Re: 2338 SW Old Port Road (Lot 725, Eagle Creek)

Vista Structural Engineering, LLC, was asked to address the following rough-in inspection item for the house being built at 2338 SW Old Port Road:

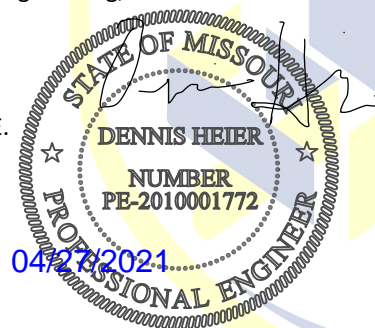
Does hole drilled vertically through LVL for wire, as shown on the following page, affect the structural integrity of the LVL? *The hole drilled vertically does not affect the structural integrity of the LVL. The bearing condition is achieved at the studs adjacent to the garage door, and the sheathing along the exterior is uninterrupted along the length of the LVL. We therefore recommend approval of the LVL as it is currently installed, with the drilled vertical hole.*
